BELL BEND NUCLEAR POWER PLANT
RESPONSE TO RAI No. 37 AND
SCHEDULE INFORMATION
BNP-2009-244 Docket No. 52-039

References: 1) M. Canova (NRC) to R. Sgarro (PPL Bell Bend, LLC), Bell Bend COLA – Request for Information No. 37 (RAI No. 37) – SEB1 -2659, 2660, 2661, e-mail dated July 27, 2009

Response to NRC Request for Additional Information No. 37
Bell Bend Nuclear Power Plant

FIGURE 1-1

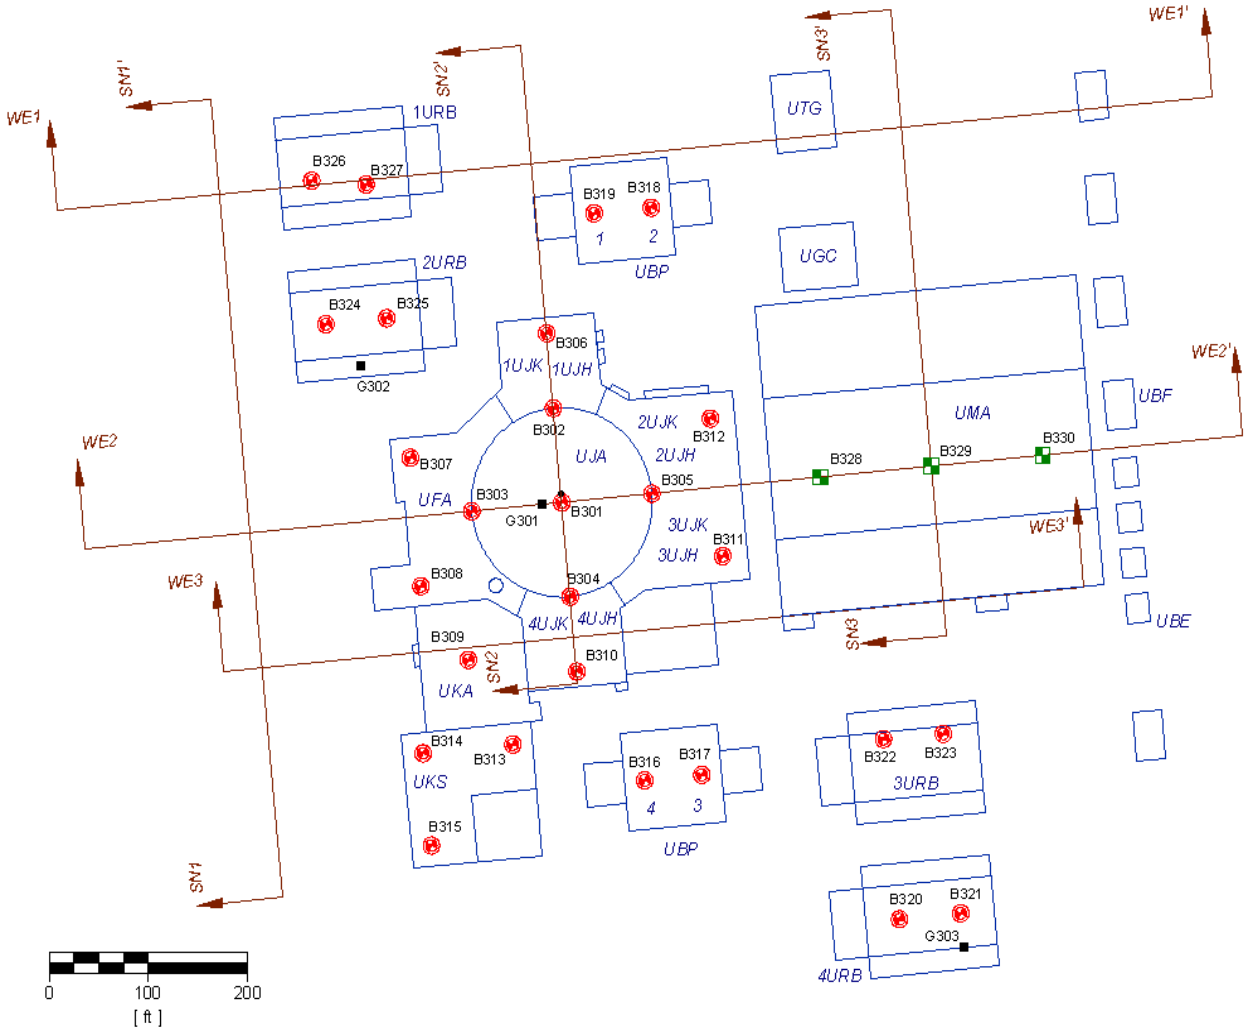
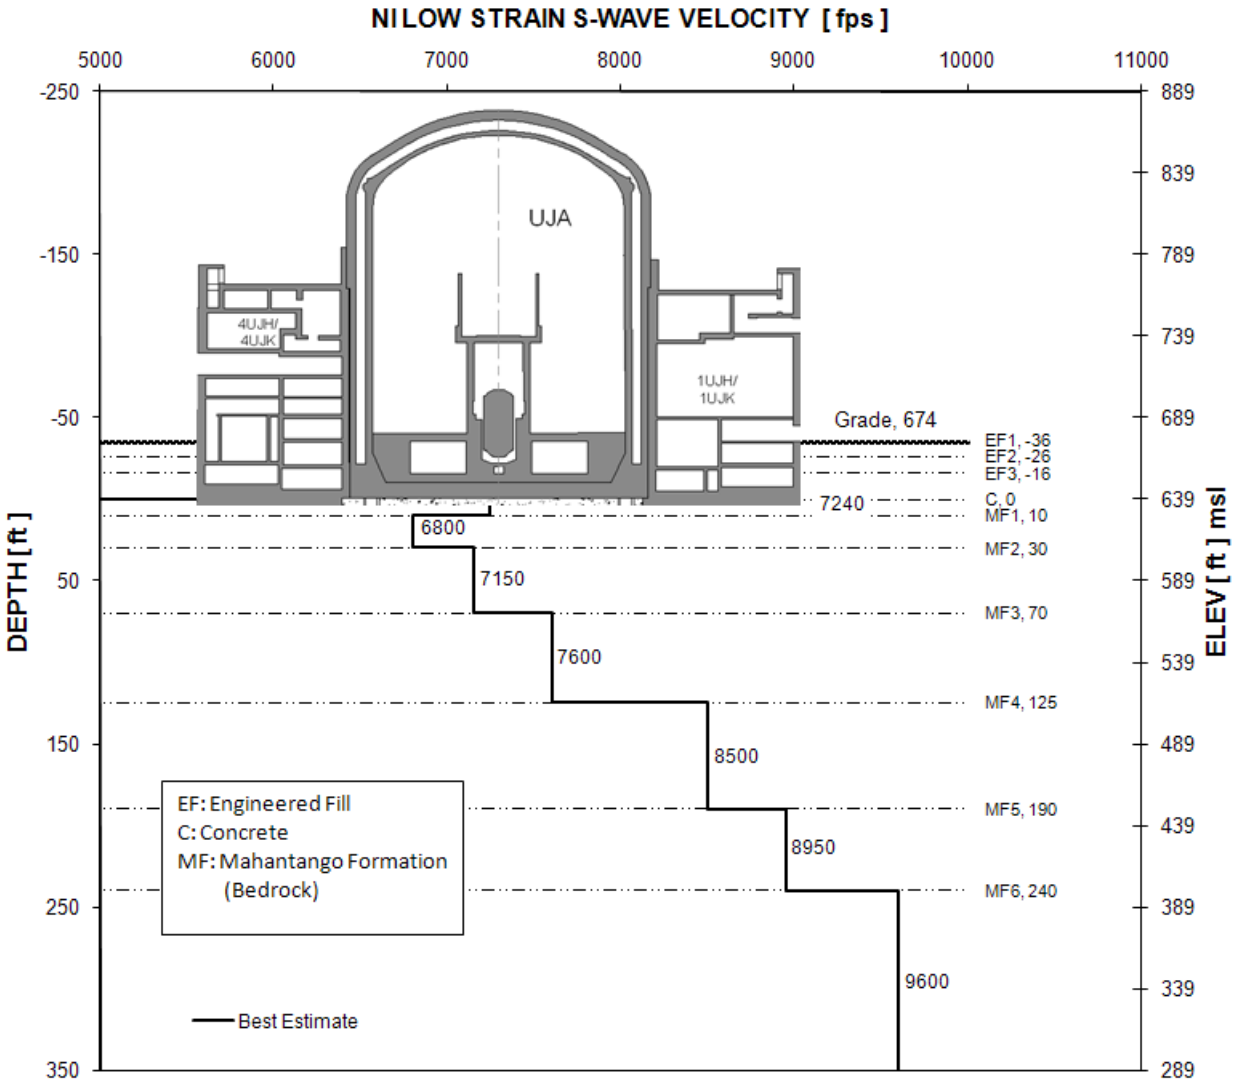
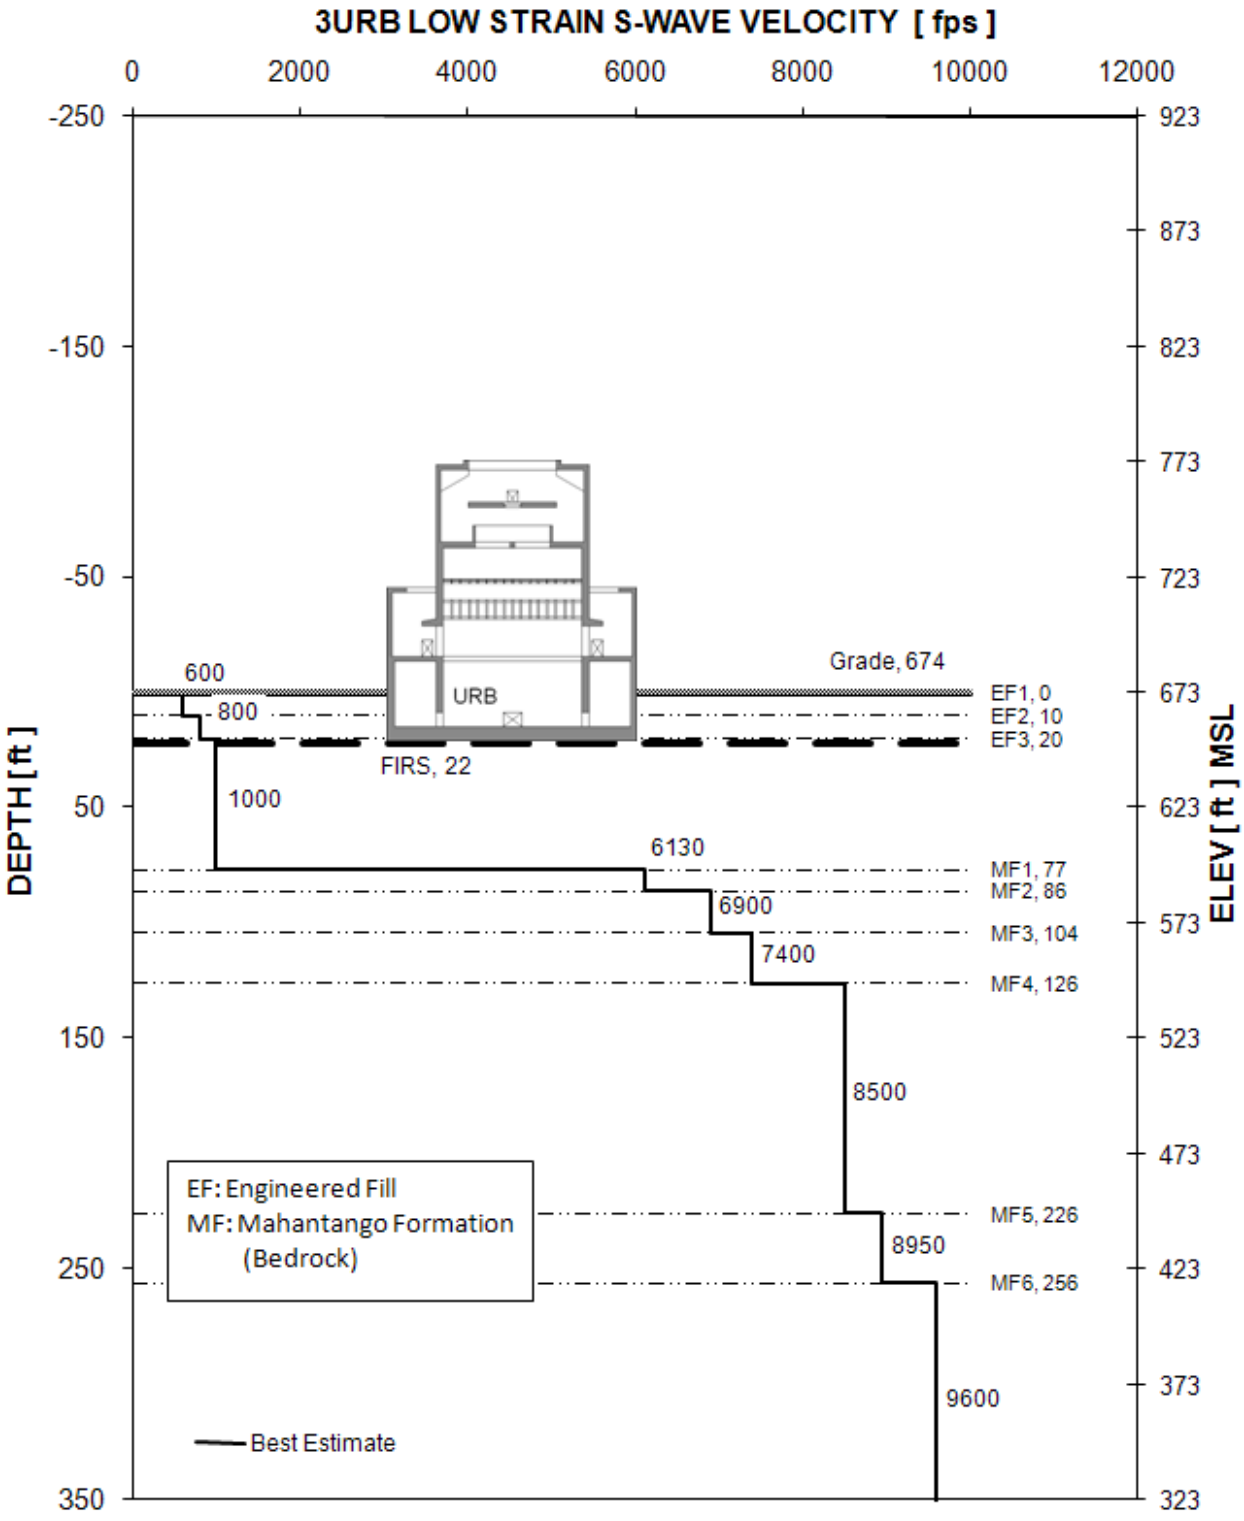
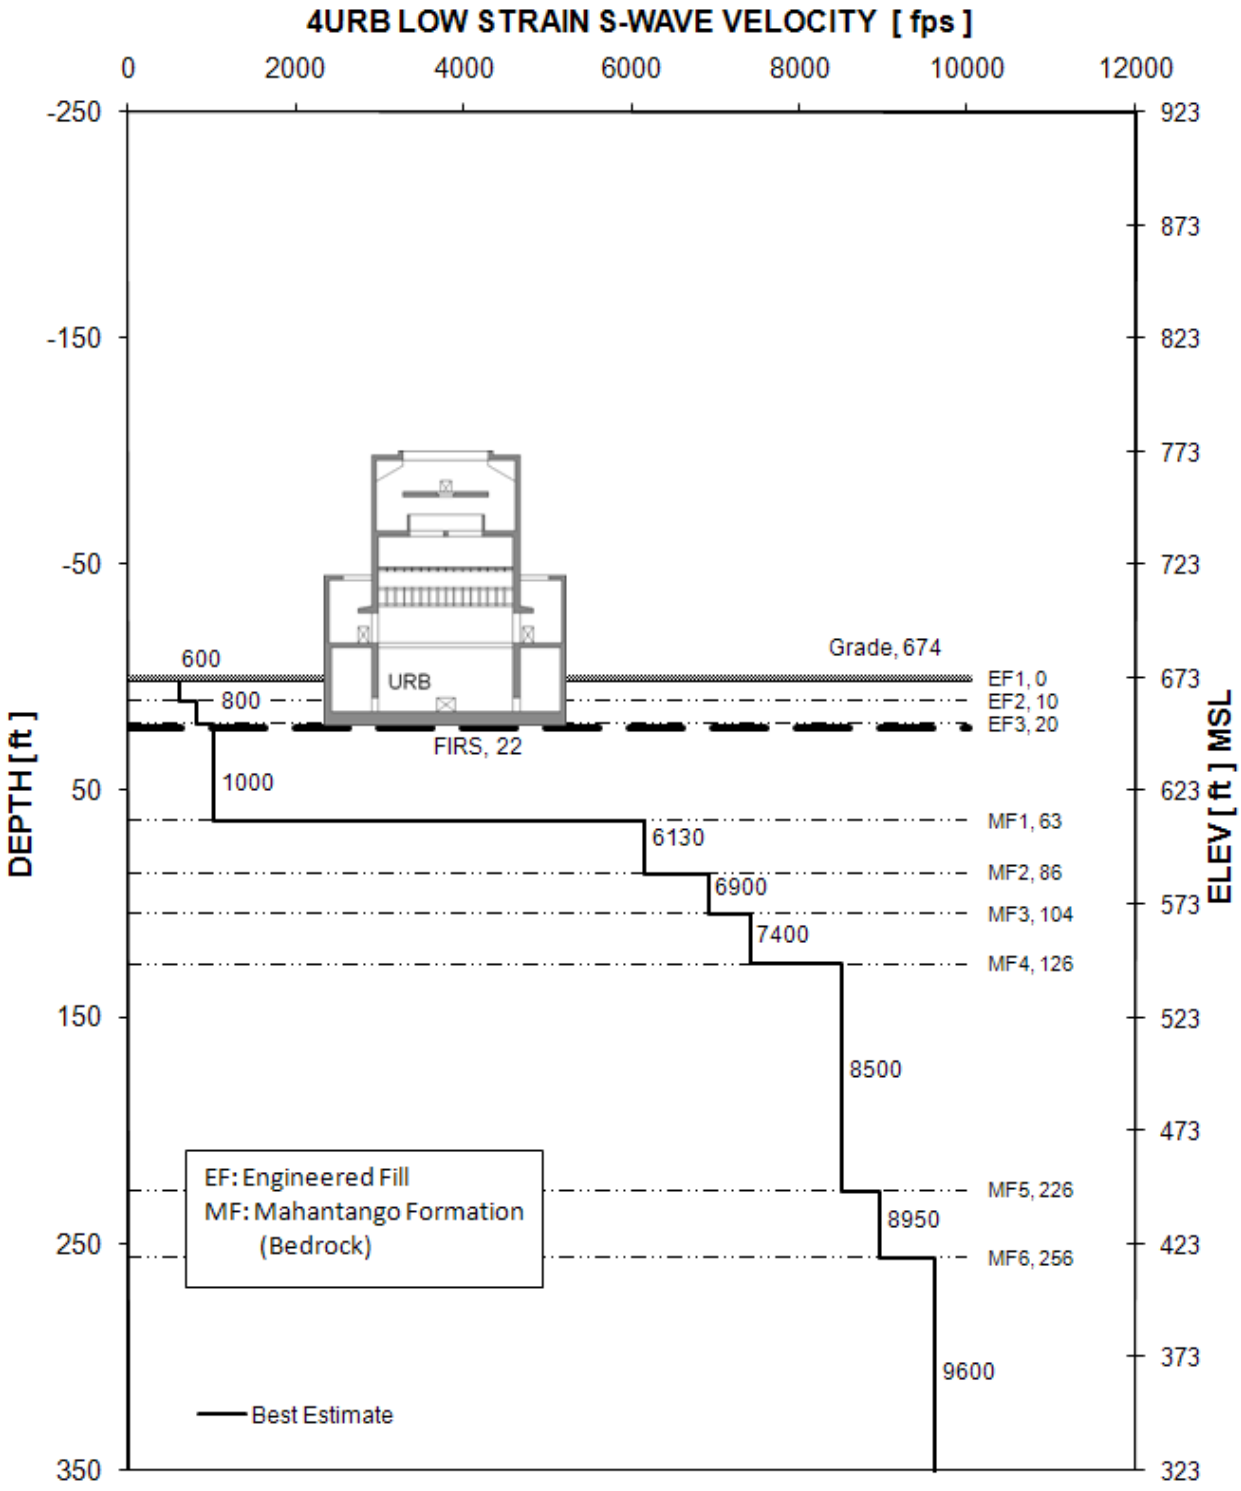
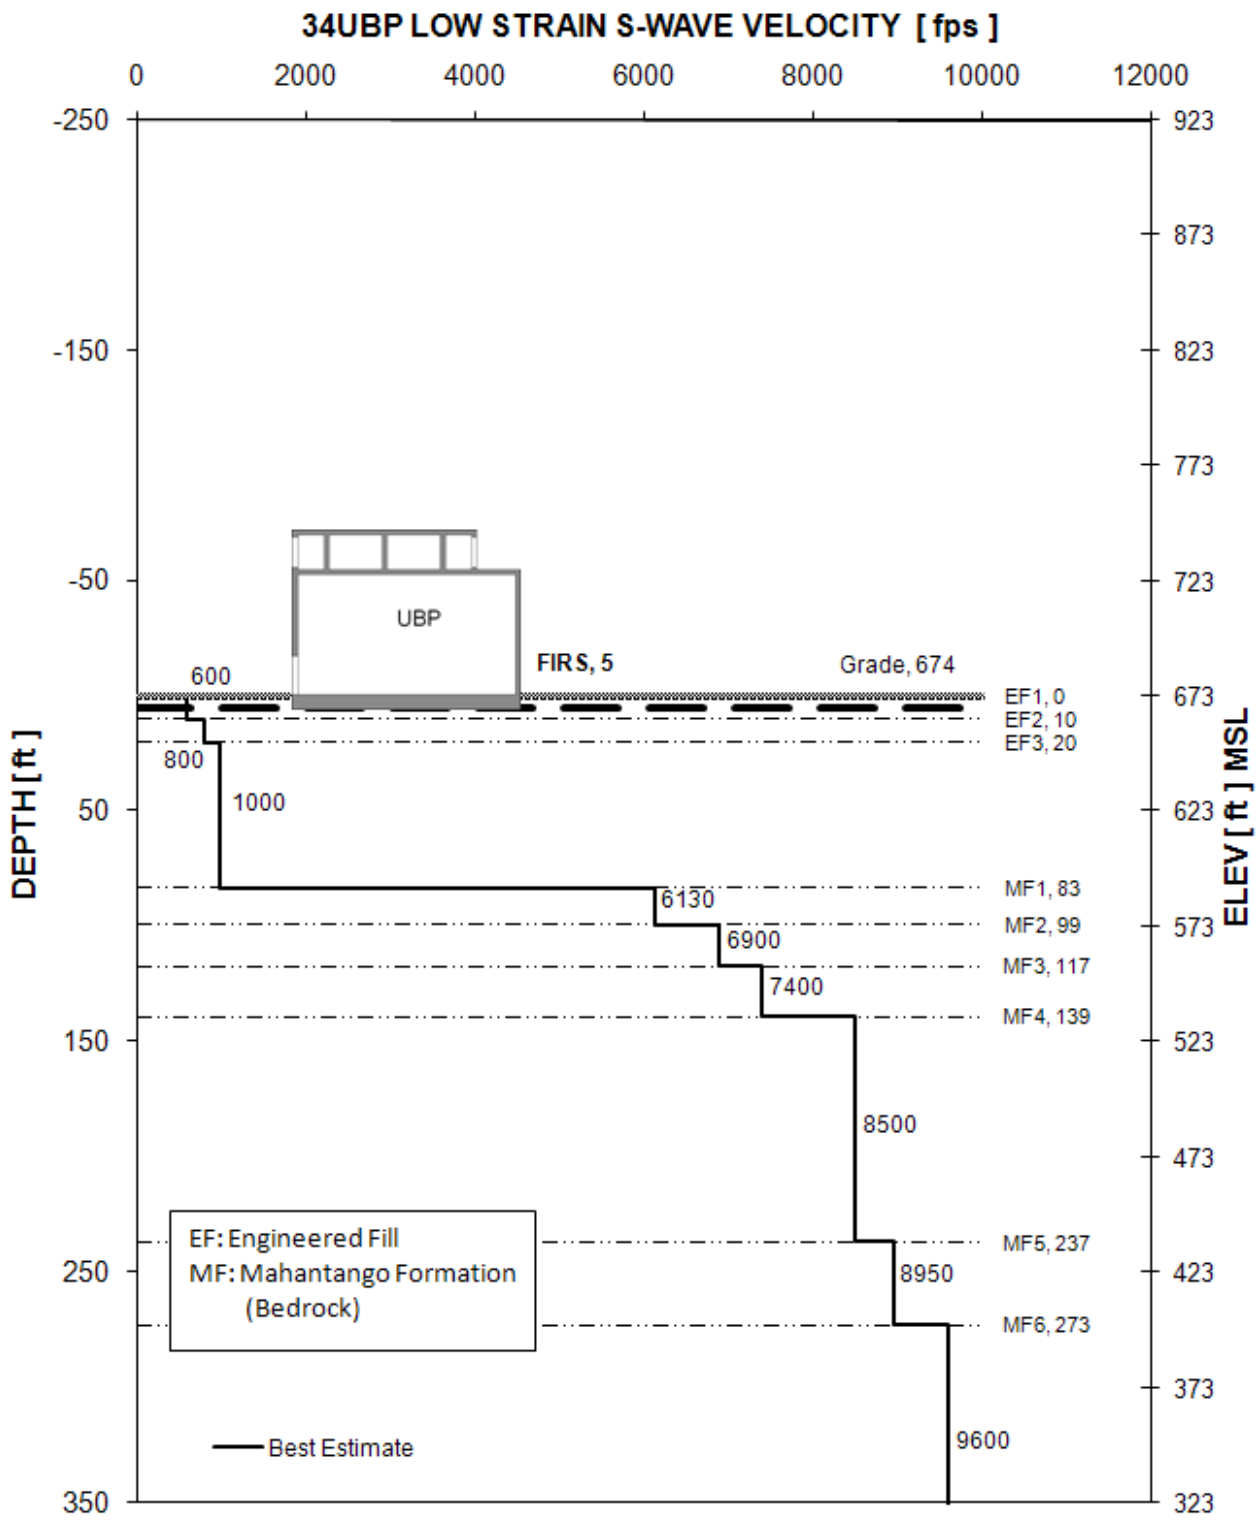
1) Describe in detail the process used to develop the FIRS and indicate if the FIRS were developed in a probabilistic manner. State if the site profiles used in the calculations were based on the geologic outcrop at the foundation elevation of each structure.

The FIRS for each building in the power block area was developed independently to accommodate a specific soil column. A figure is provided for each of the facilities as follows:

- Figure 1-1 – General plan view and building nomenclature
- Figure 1-2 – Soil profile underneath the Nuclear Island (NI)
- Figure 1-3 – Soil profile underneath 3URB (ESWB)
- Figure 1-4 – Soil profile underneath 4URB (ESWB)
- Figure 1-5 – Soil profile underneath 3UBP and 4UBP (EPBG)
- Figure 1-6 – Soil profile underneath 1URB and 2URB (ESWB)
- Figure 1-7 – Soil profile underneath 1UBP and 2UBP
